[Applicant's Supplemental Information in Support of DSRFY2019-25](#)

Re: DSRFY2019 - 18

CLIENT
INFLECTION DEVELOPMENT
PARKWAY LOT 50
GARDEN CITY, ID 83714

3rd Floor (Podium Deck Level)

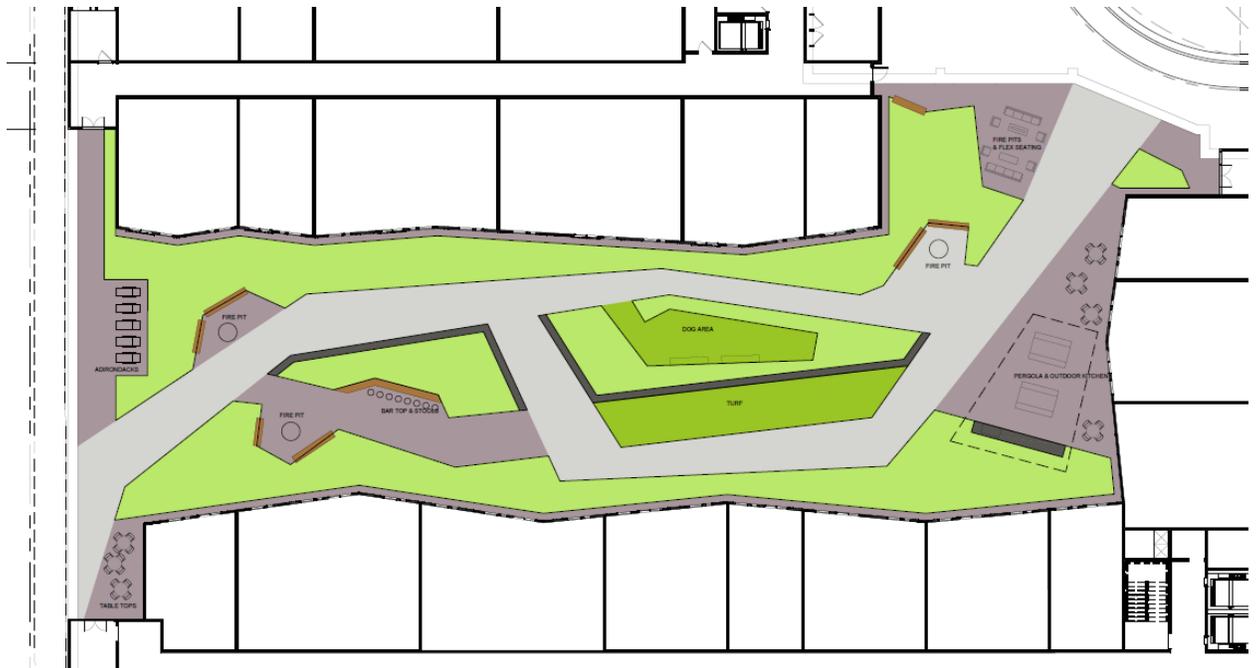
2. GCC 8-2C-15 requires multi-family dwelling units to have four amenities, and other items. Please demonstrate how you comply with this section.

The Parkway Lot 50 project has many amenities. See plans and Roofdeck .pdf file.

Community Room 416 SF

Outdoor Kitchen/BBQ pits

Fire Pit (4)

Seating Nooks (7)

Dog Play Area (dog run)

EXTERIOR
ELEVATIONS

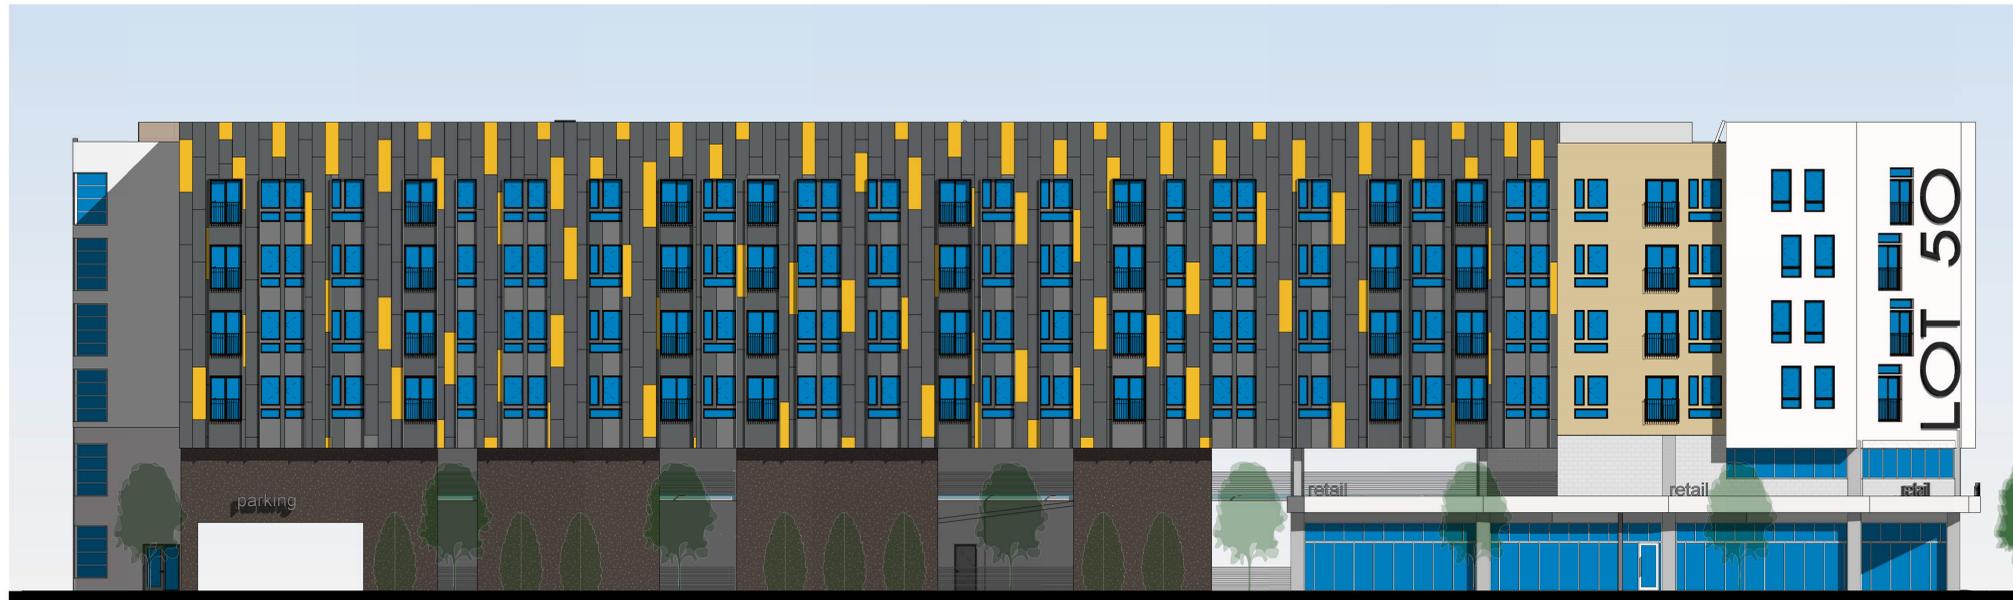
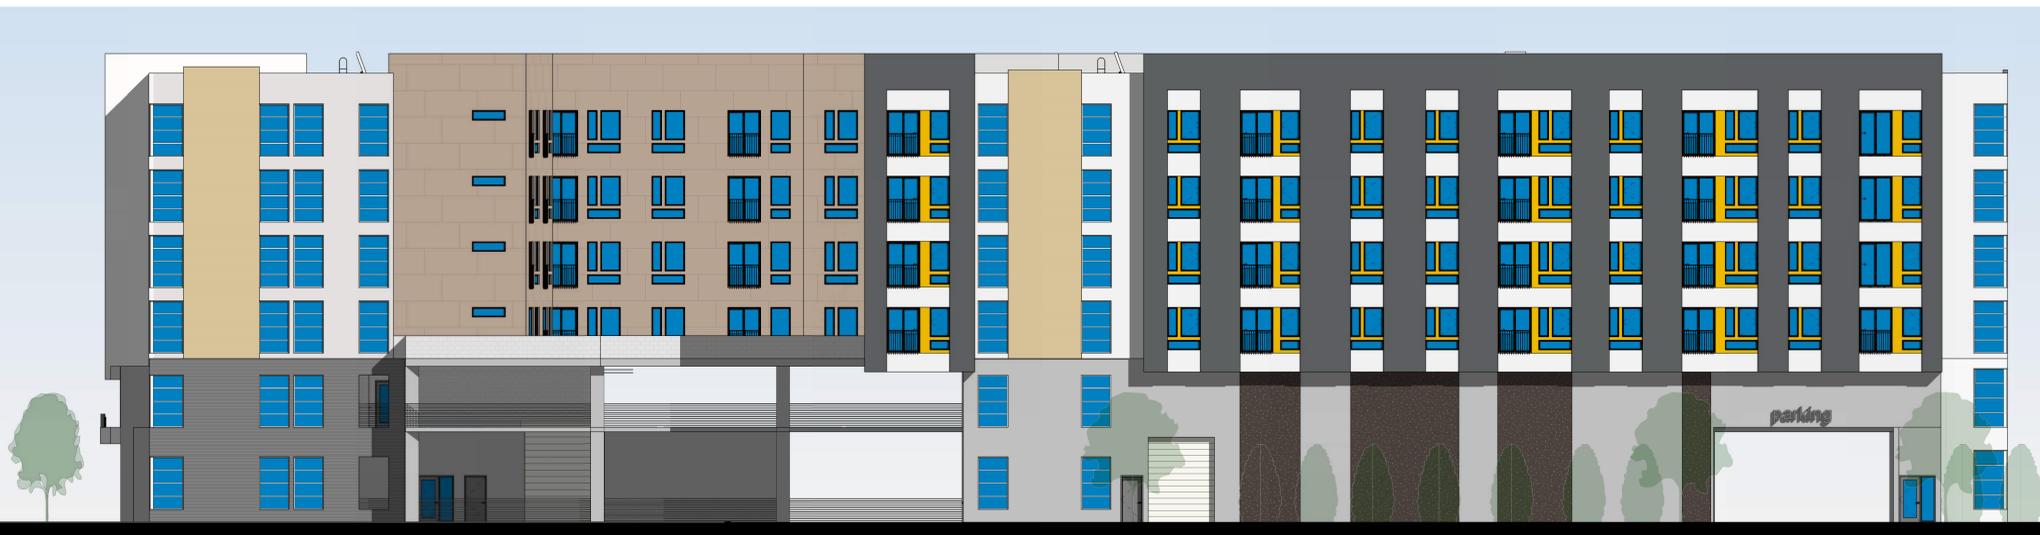
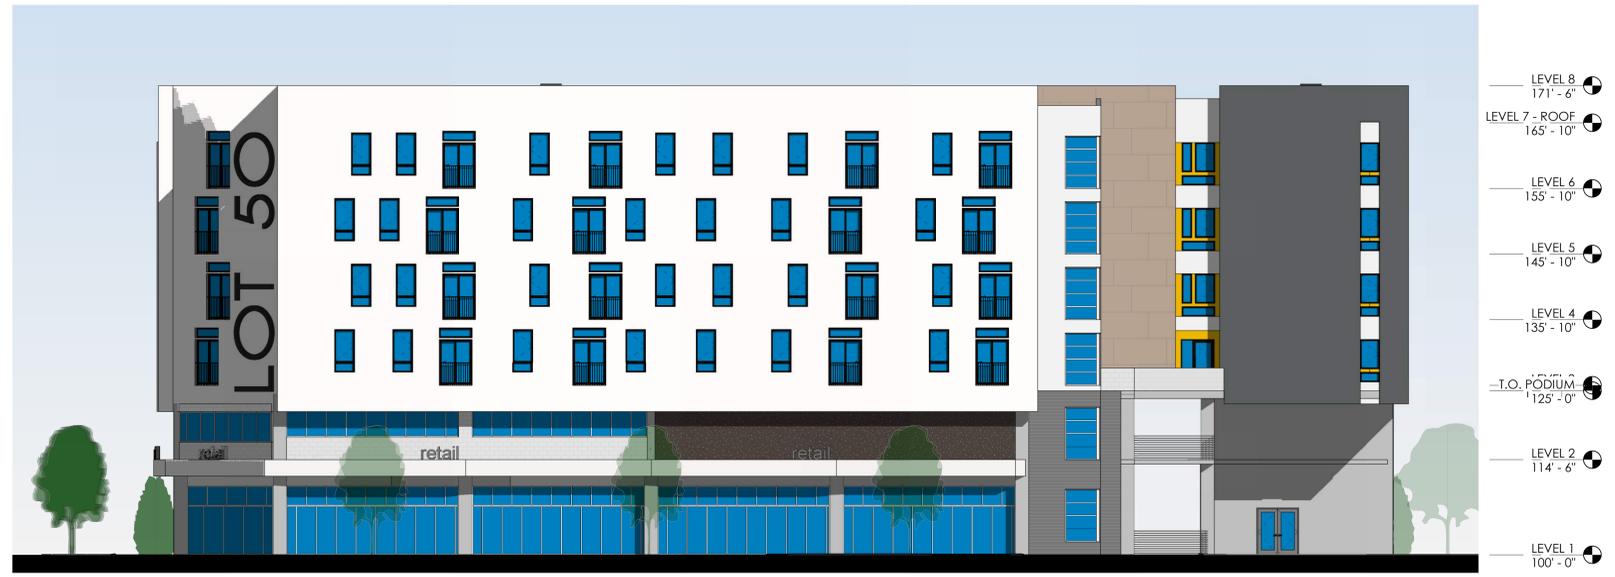
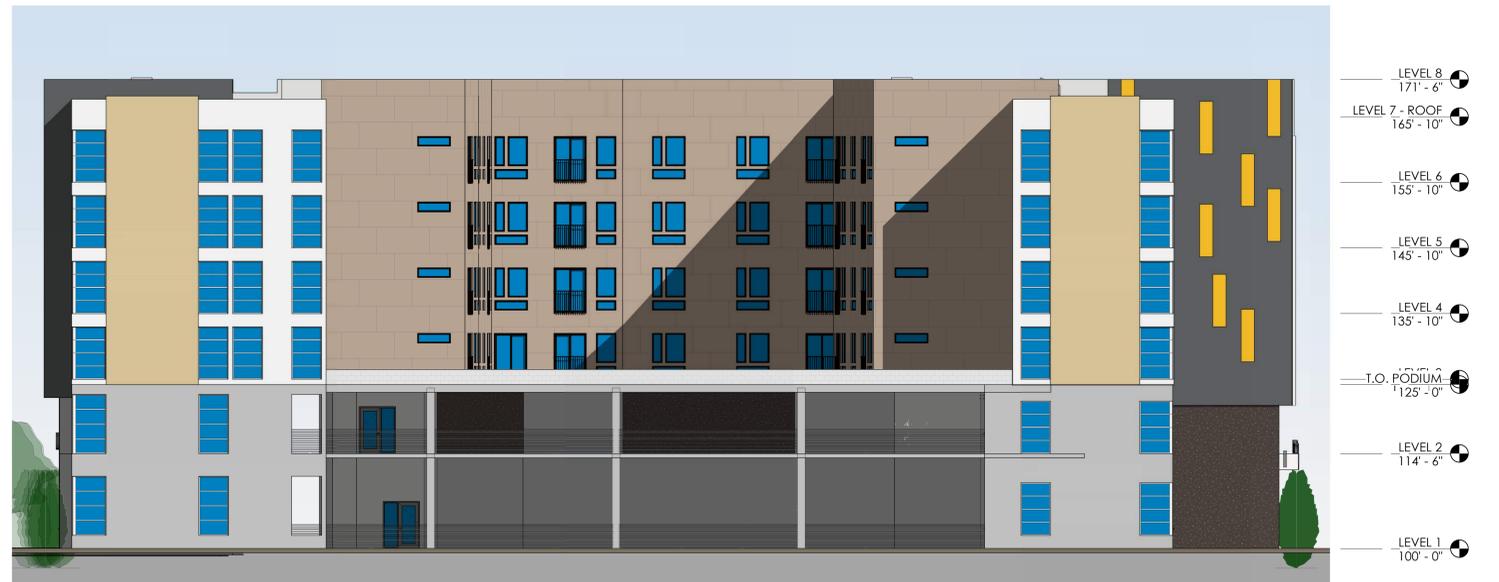
- 2. Comment: The height limit in the M zone is 72', but the elevations show 75'. Please advise how you came to 75'.**

Response: The elevation shows the top of the building is 71', we have added a parapet of 4' for aesthetic screening. Parapets have not been interpreted as a component of the building height in the Garden City ordinance. We can screen the mechanical by pushing it back further from the facade line, but we feel this will be the most aesthetically pleasing.
